UN/SCETDG/61/INF.59 UN/SCEGHS/43/INF.35

Amendments to the classification of desensitized explosives according to the GHS

**Transmitted by the experts from Germany, the United States of
America and the United Kingdom**

Amended version of Chapter 2.17 of the GHS (clean version)

Decision logic 2.17.1 for desensitized explosives

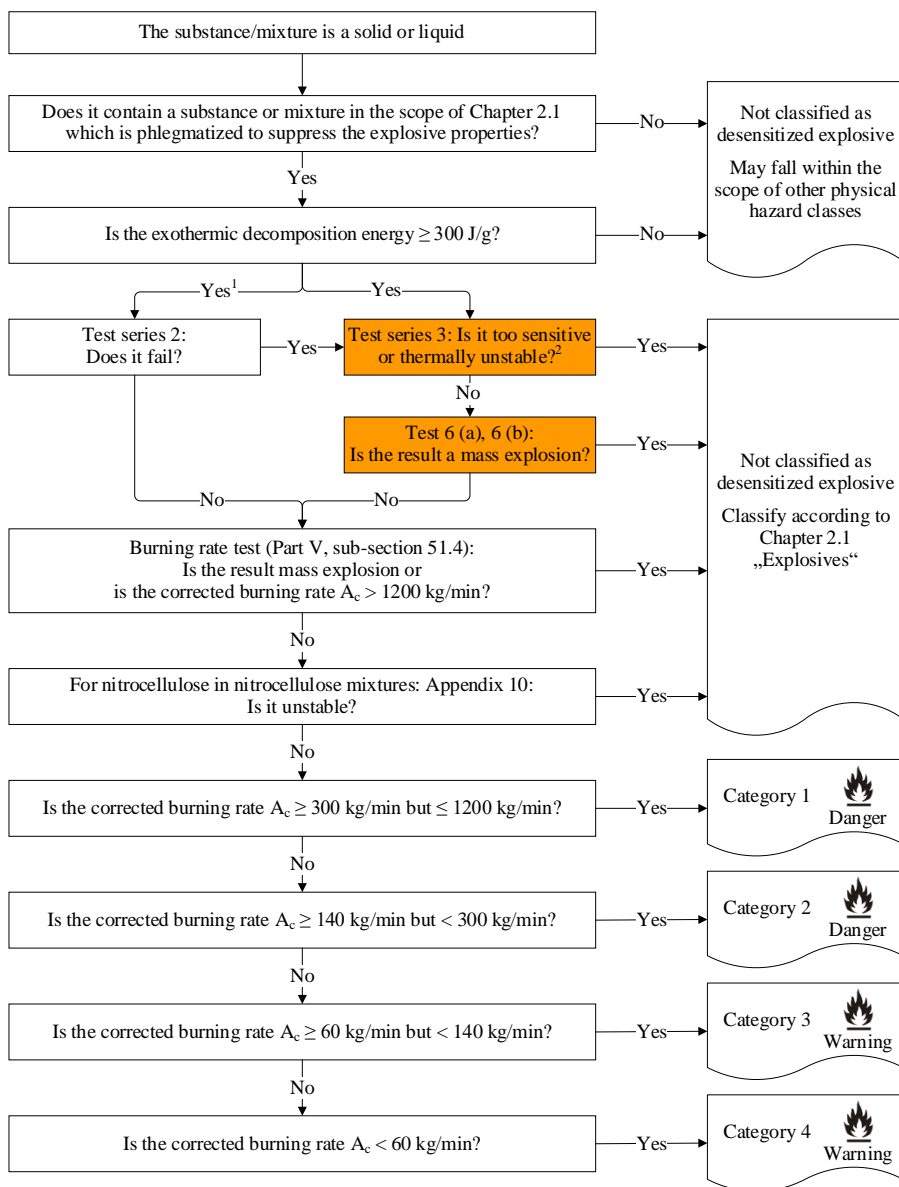
Commented [CW4]: Based on the proposal by AEISG-document UN-SCEGHS-43-INF12e-UN-SCETDG-61-INF20e: The order of the boxes marked in orange has been reversed. However, other than in the proposal by AEISG, the box with test series 2 must be positioned such that it does not bypass the box with test series 3 in case test series 2 is failed.

Commented [CW5]: Amendment in footnote 2 is based on UK document UN-SCEGHS-43-INF18e_UN-SCETDG-61-INF42e, paragraph 7.

¹ Test series 2 is optional. The alternative route (via test 6 (a) and (b) and test series 3) may be taken directly without performing test series 2.

² Test series 3 is not applicable to nitrocellulose mixtures containing no other explosives other than nitrocellulose.
